THIS DRAWING HAS BEEN UPDATED TO INCORPORATE CHANGES MADE TO THE BID DOCUMENTS BY ADDENDA. IT IS ISSUED FOR THE CONVENIENCE OF THE CONTRACTOR AND DOES NOT REPLACE THE CONTRACT DOCUMENTS AS ENUMERATED IN THE CONTRACT.

M001

**Port Townsend School District No. 50
 GRANT STREET ELEMENTARY SCHOOL
 REPLACEMENT PROJECT**
 1637 GRANT STREET, PORT TOWNSEND, WA 98368

LOWER LEVEL -
FOUNDATION
PLAN - AREA B

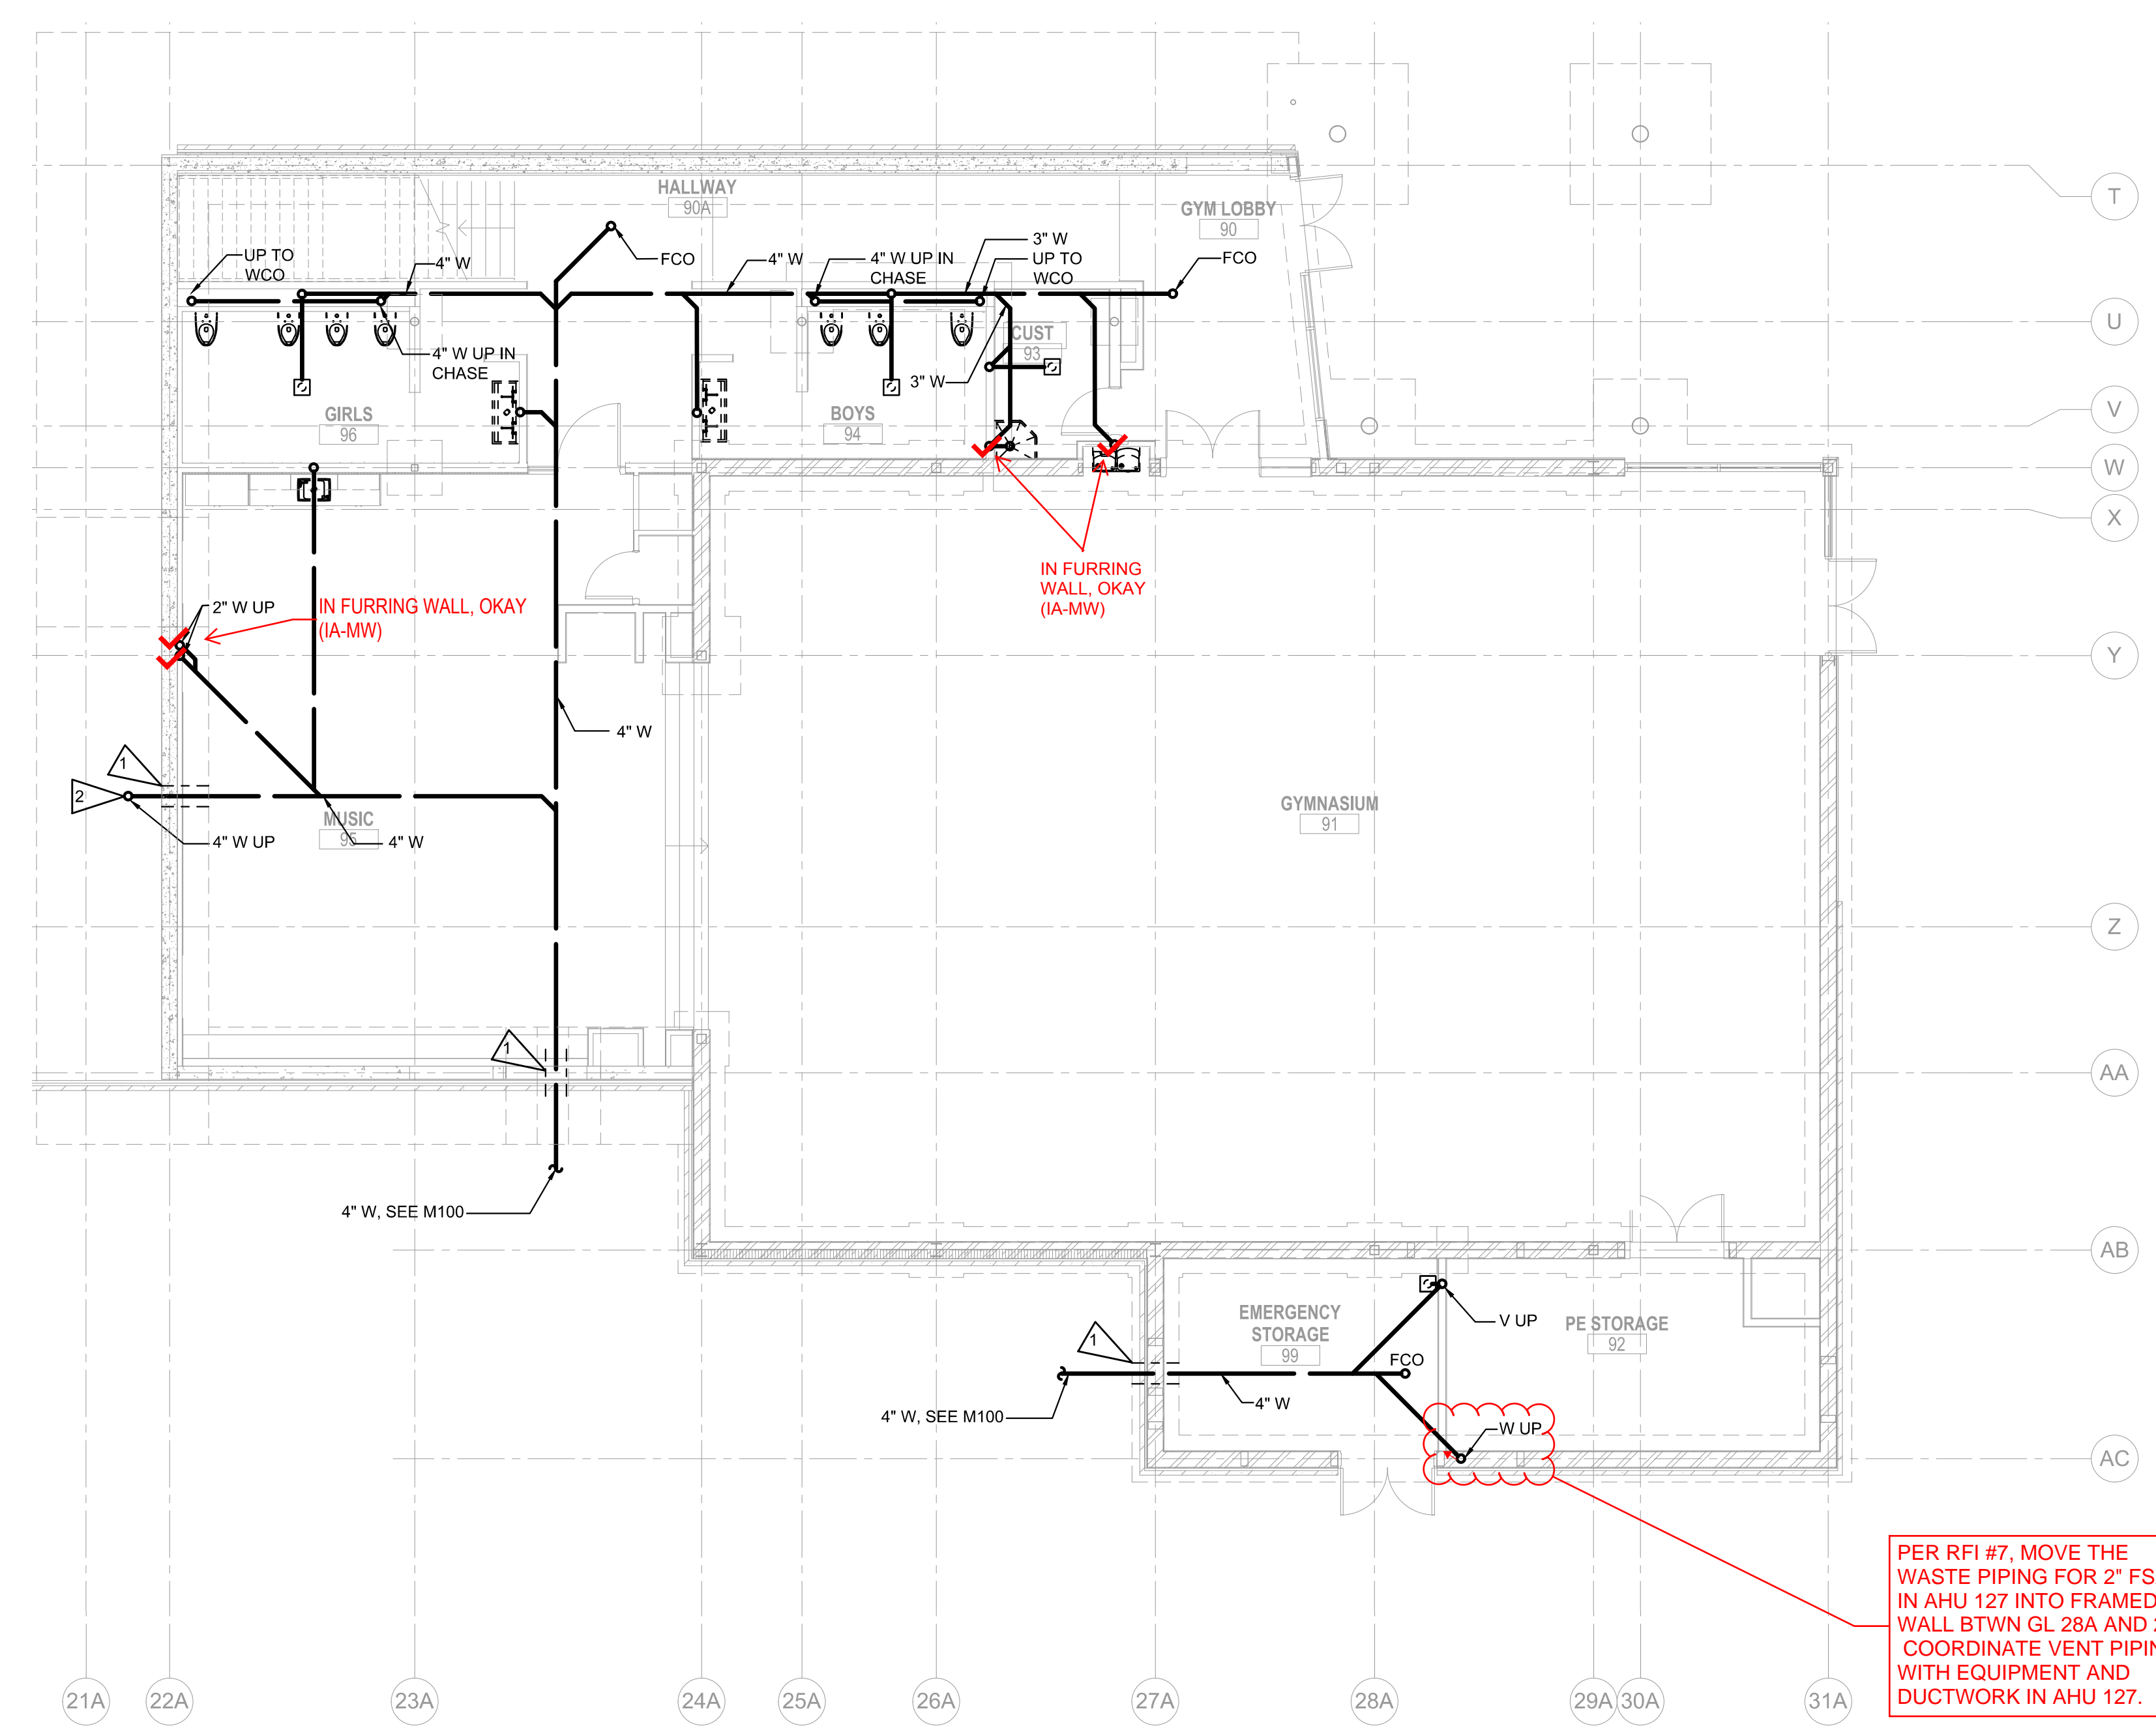
RFI CHANGES ON SHEET
-RFI #7
-RFI 060

PER RFI #7, MOVE THE WASTE PIPING FOR 2" FS2-1 IN AHU 127 INTO FRAMED WALL BTWN GL 28A AND 29A. COORDINATE VENT PIPING WITH EQUIPMENT AND DUCTWORK IN AHU 127.

LOWER LEVEL -
PLUMBING
FLOOR PLAN -
AREA B

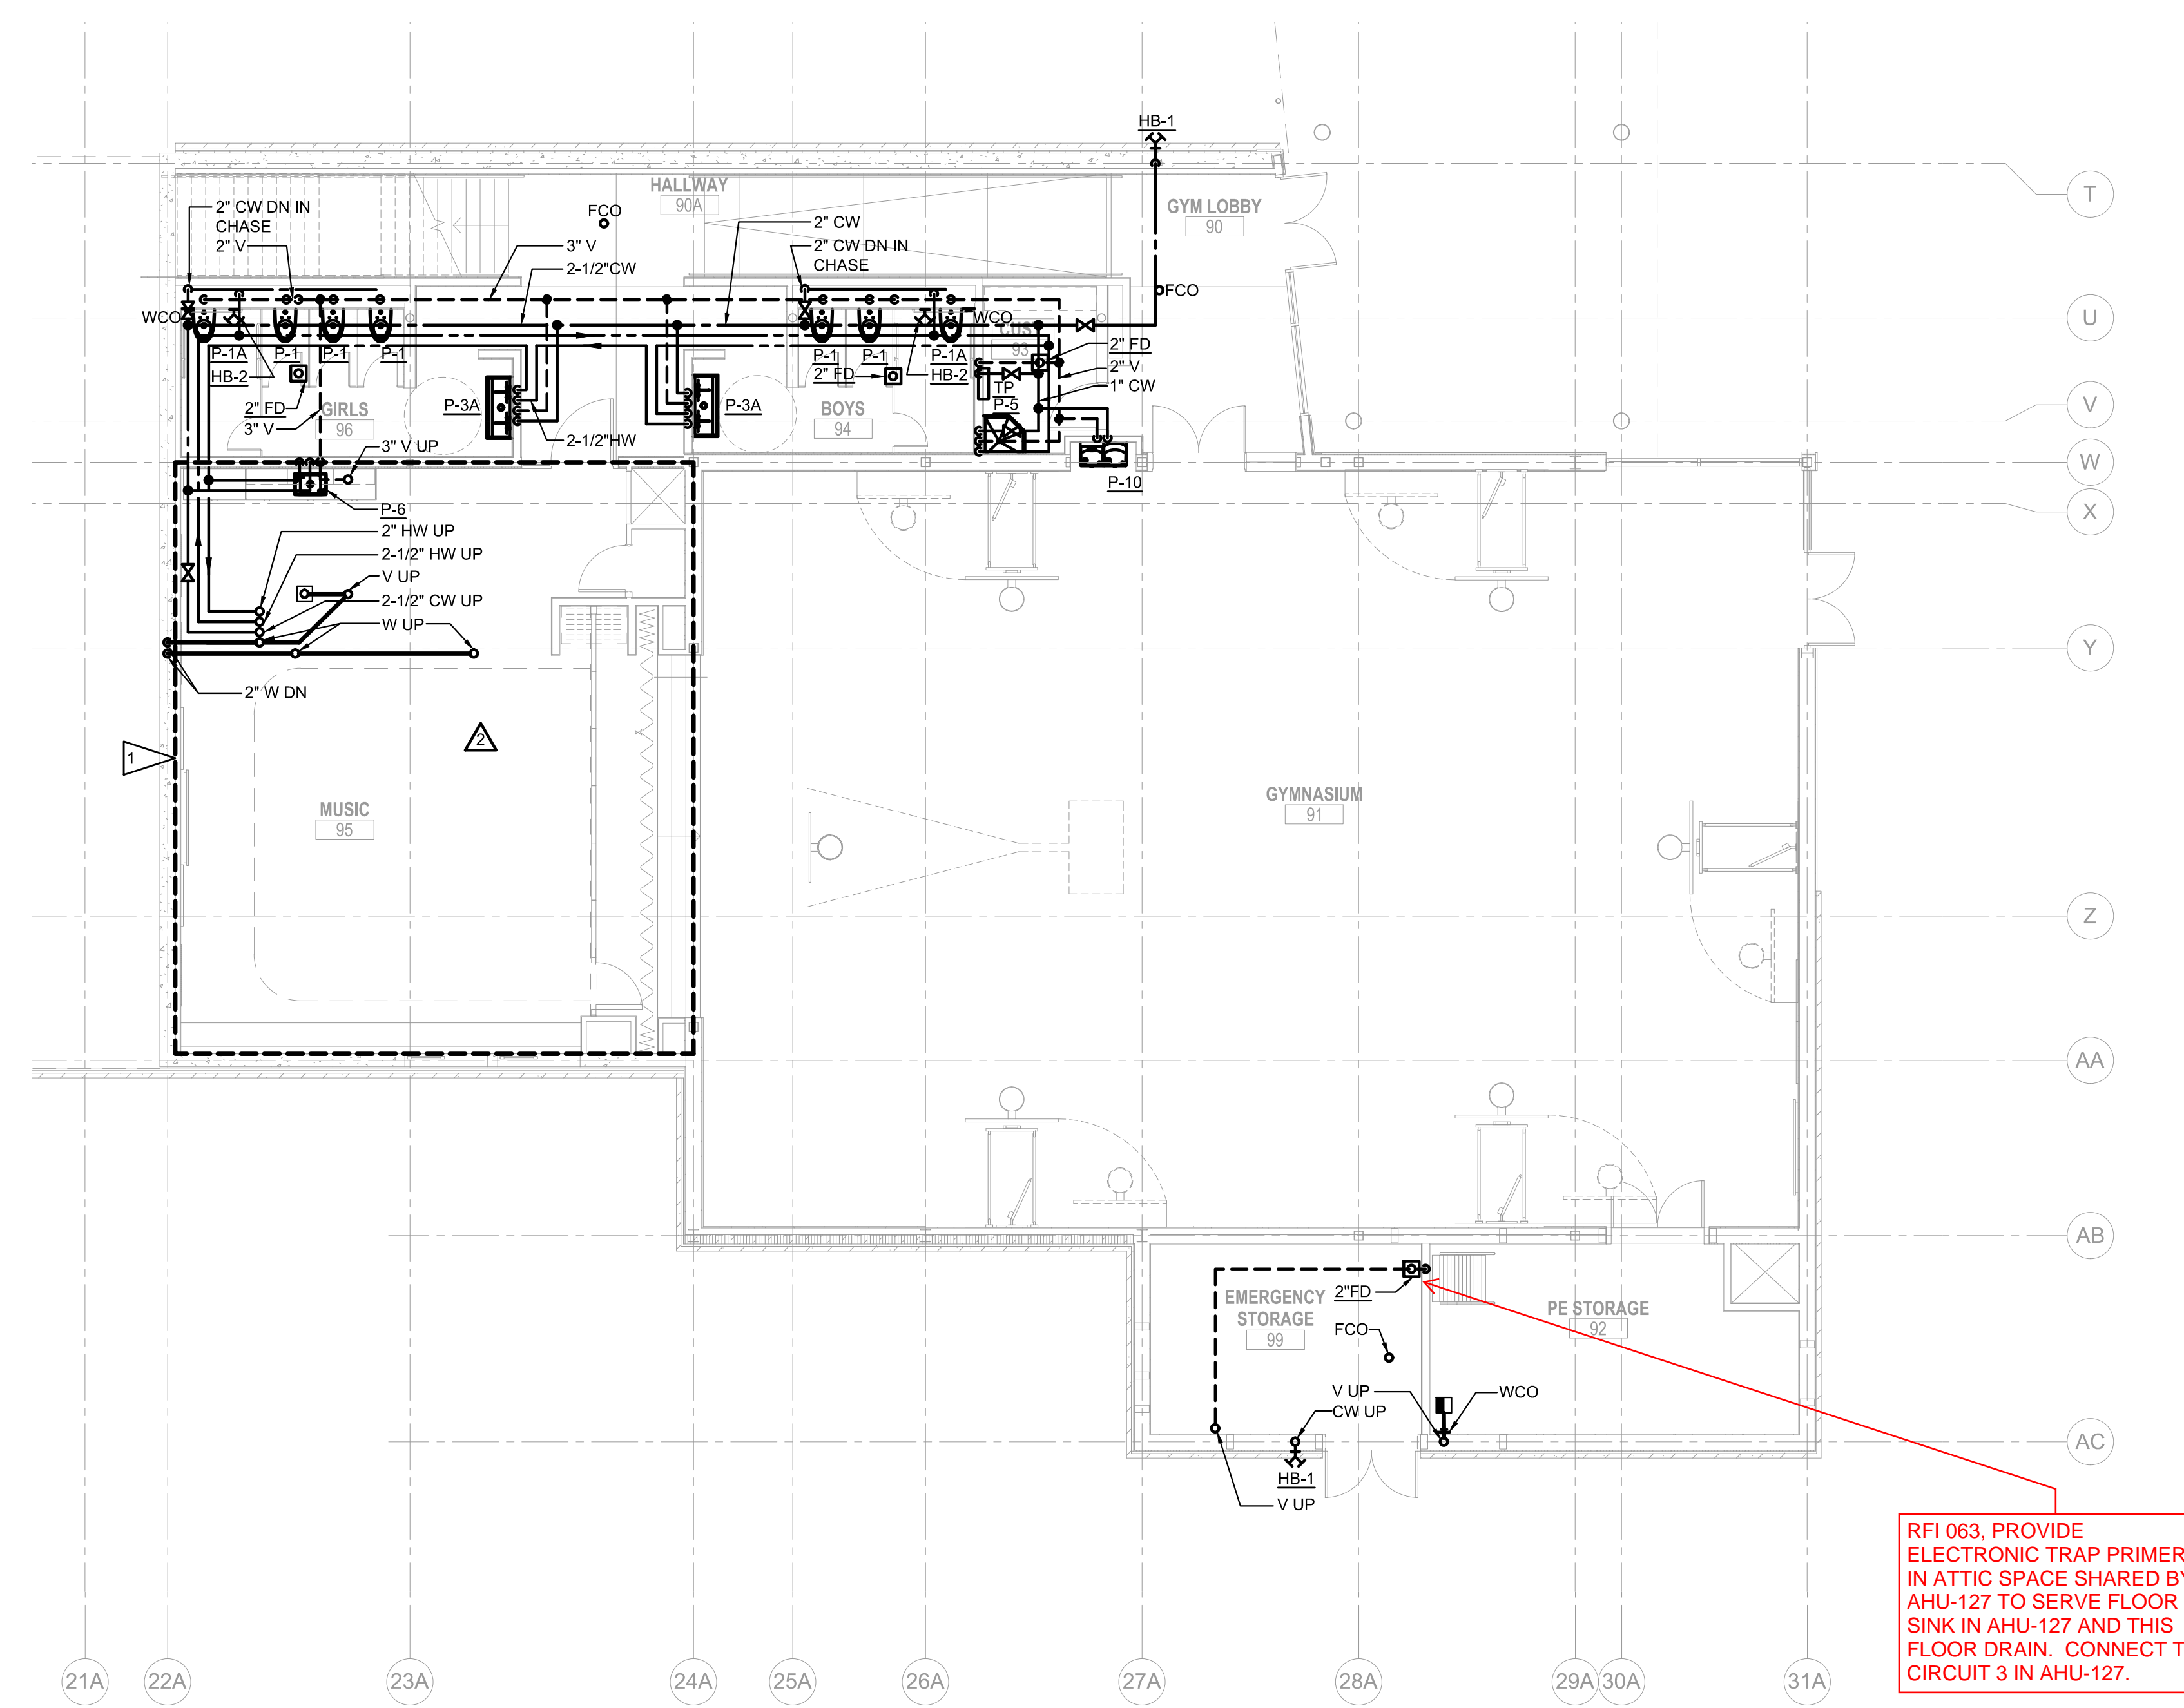
RFI 063, PROVIDE ELECTRONIC TRAP PRIMER IN ATTIC SPACE SHARED BY AHU-127 TO SERVE FLOOR SINK IN AHU-127 AND THIS FLOOR DRAIN. CONNECT TO CIRCUIT 3 IN AHU-127.

UPPER LEVEL - PLUMBING FLOOR PLAN - AREA B
 SCALE: 1/8" = 1'-0"

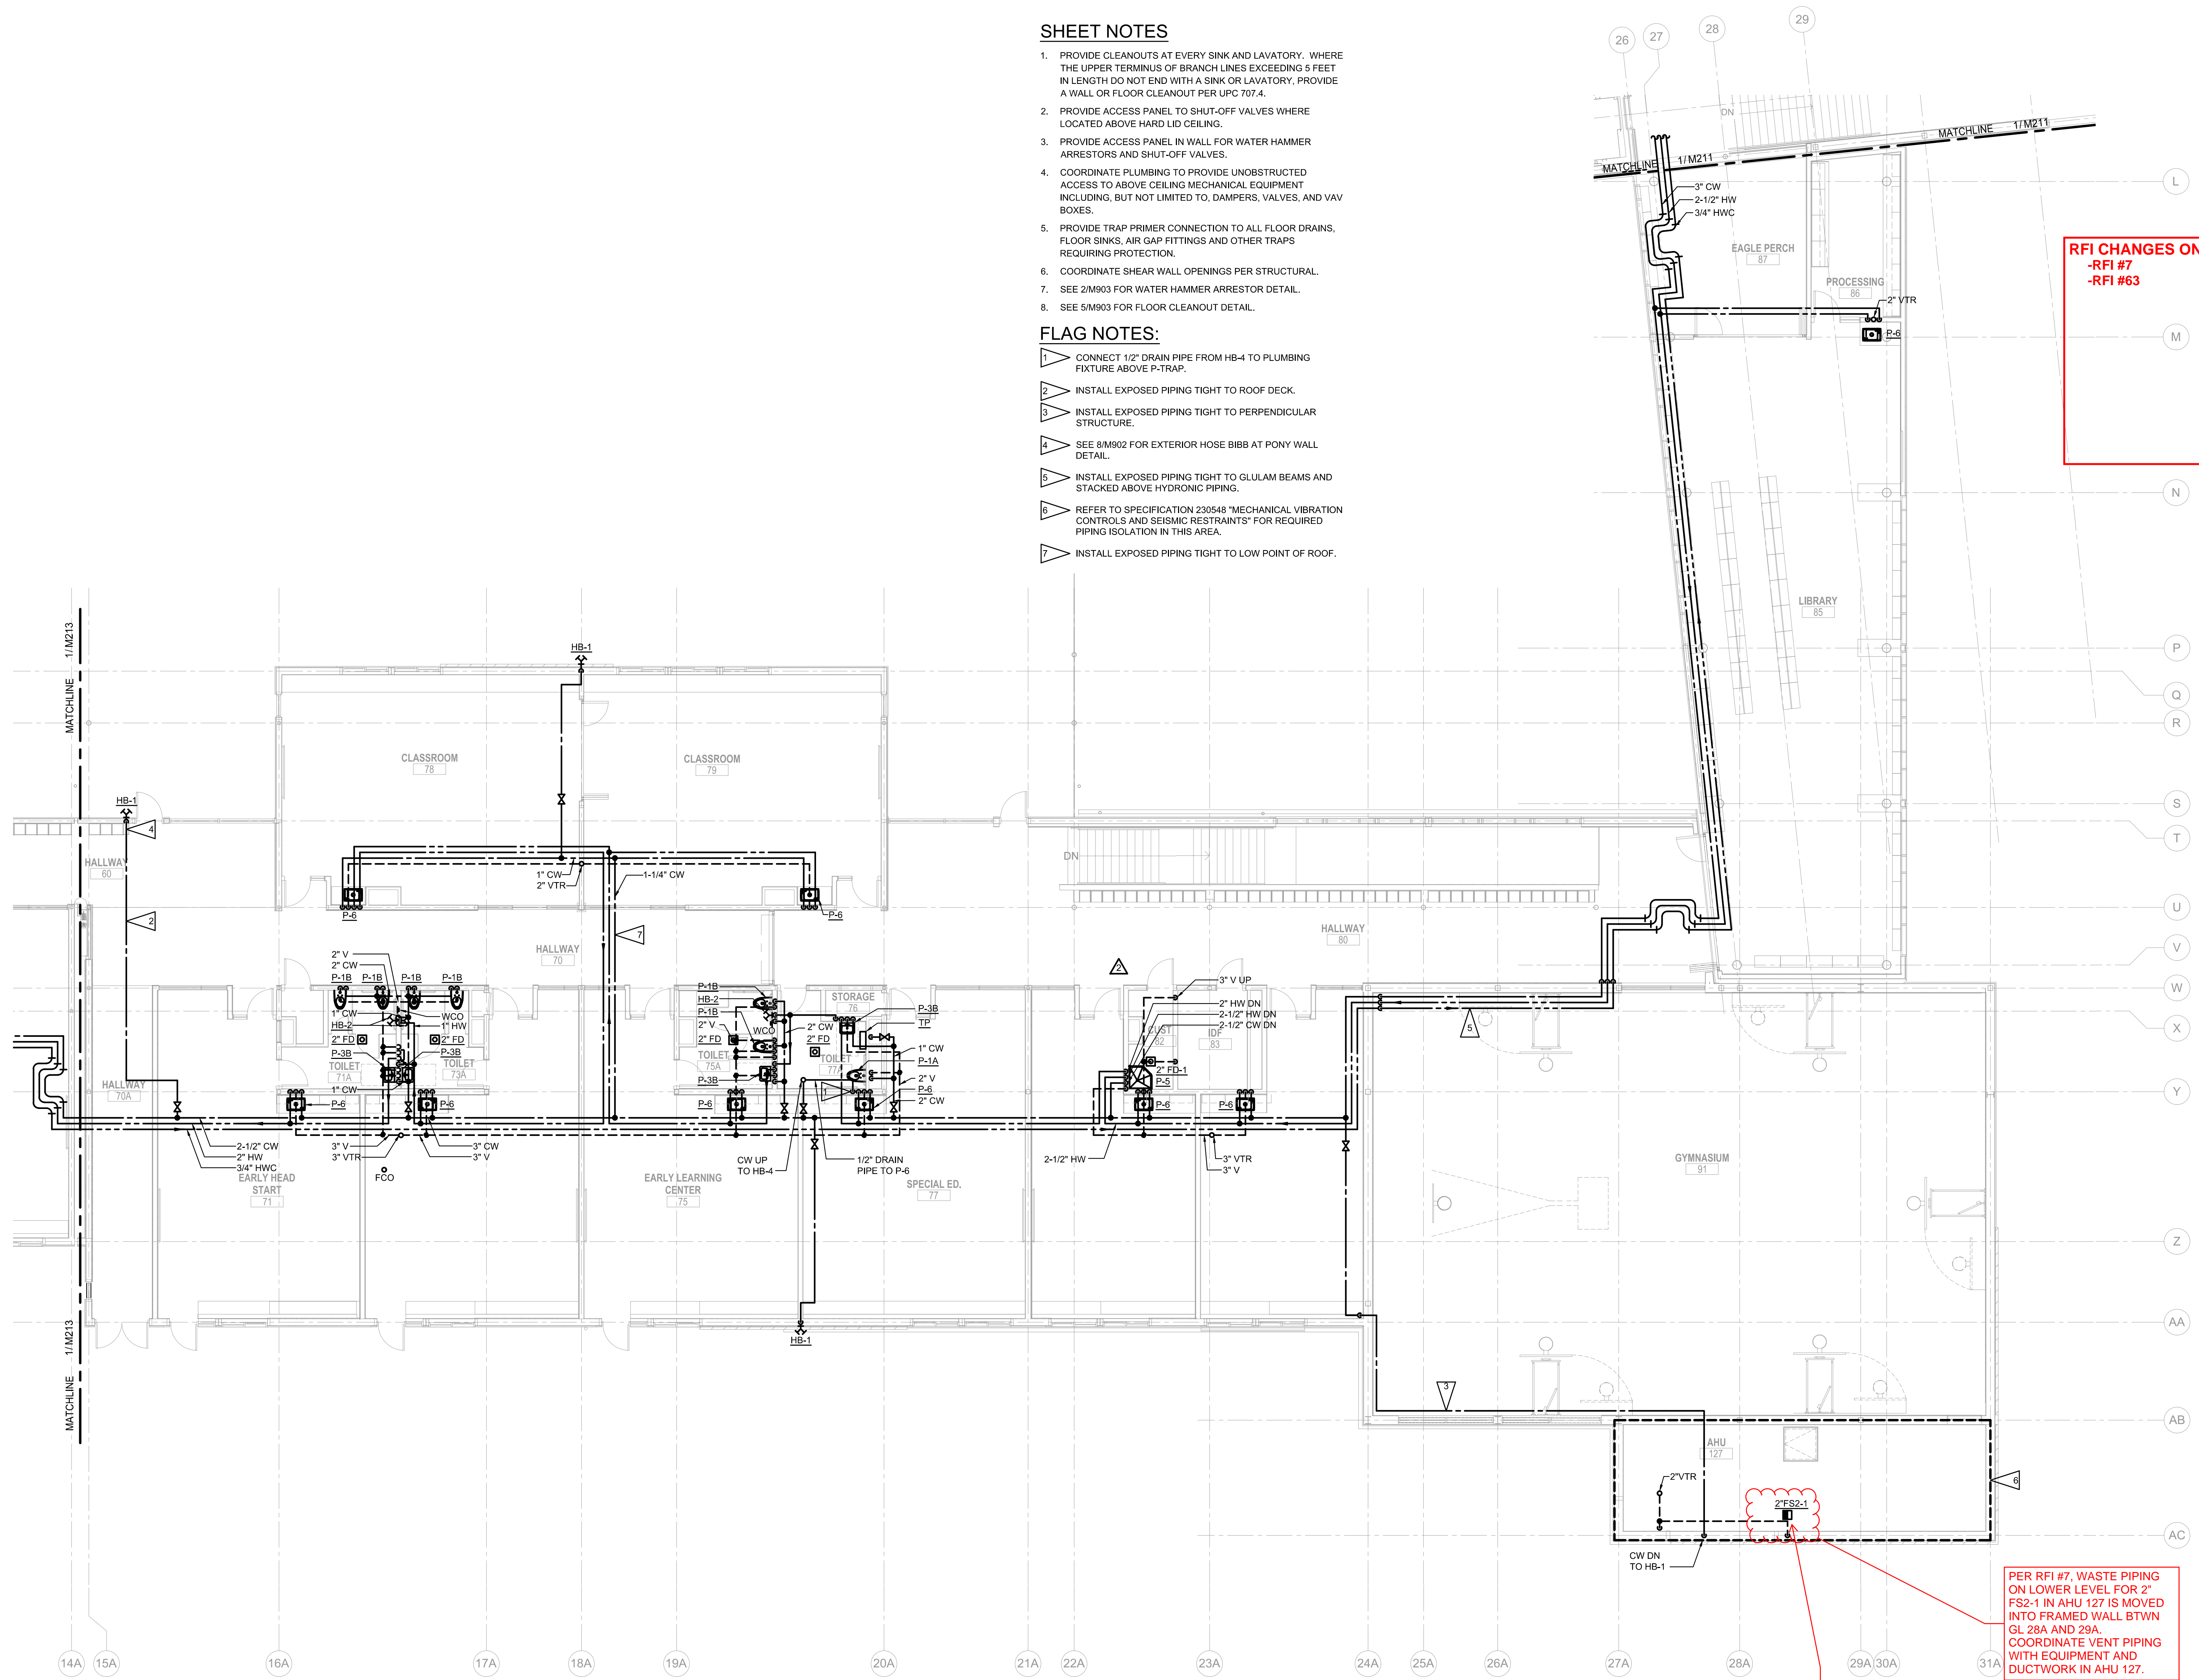
RFI CHANGES ON SHEET
 -RFI #7
 -RFI #63

PER RFI #7, WASTE PIPING ON LOWER LEVEL FOR 2" FS2-1 IN AHU 127 IS MOVED INTO FRAMED WALL BTWN GL 28A AND 29A. COORDINATE VENT PIPING WITH EQUIPMENT AND DUCTWORK IN AHU 127.

RFI 063, PROVIDE ELECTRONIC TRAP PRIMER IN ATTIC SPACE SHARED BY AHU-127 TO SERVE FLOOR SINK IN AHU-127 AND THIS FLOOR DRAIN. CONNECT TO CIRCUIT 3 IN AHU-127.
